Technical Bulletin T163

Product: A/V Receiver

Hardware Technical Bulletin: T163-H2005-04

Date: February 28/05 **Subject:** Intermittantly shuts down

Figure 1

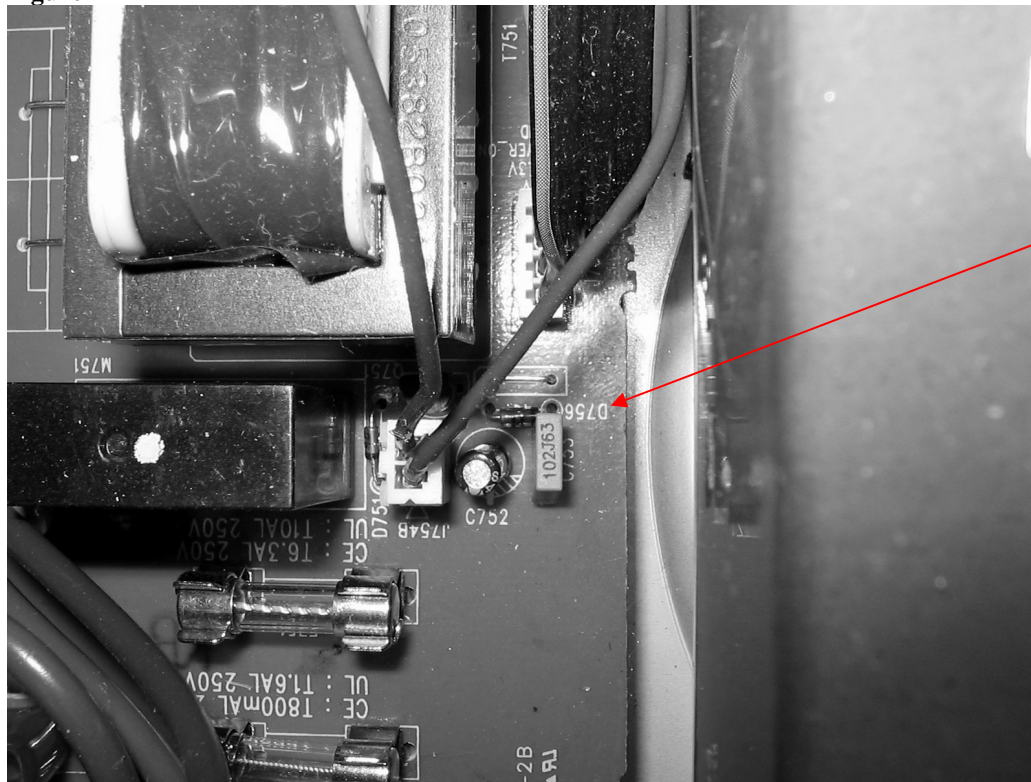
DESCRIPTION: Unit may shut down, shortly after turn on.

REASON: There is a diode on the standby board that maybe operating intermittantly.

SOLUTION: Locate and identify D756 on the standby board. Change only if the diode is a 1N4148. Change from a 1N4148 to a 1N4004 or equivalent. See figure 1 for details.

D756
CHANGE
FROM
1N4148 TO
1N4004
